# RP-RAN02 TOW POINT INSTALLATION

Compatible with FORD PX3 RANGER & EVEREST 06/2018-0N

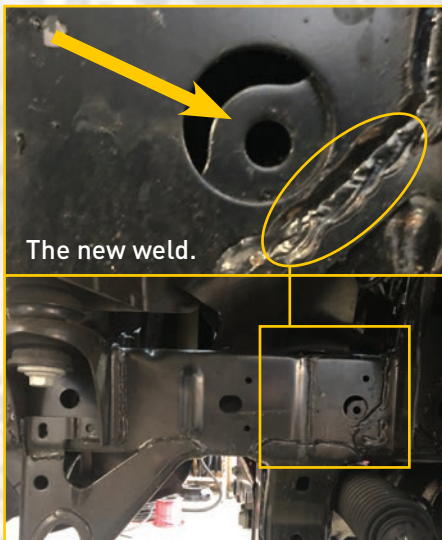
Applicable to vehicles manufactured post JUNE 2018. A stiffening plate installed inside the chassis rail affects access to one hole used in the fitment of RP-RAN02 (Refer Image). Using a step drill enlarge this hole to allow fitment of the supplied hardware. The spacer pictured will require modification to clear the new weld not present on previous vehicles.

The nut plate will sit behind the stiffening plate, with the bolt passing through.

The new weld.
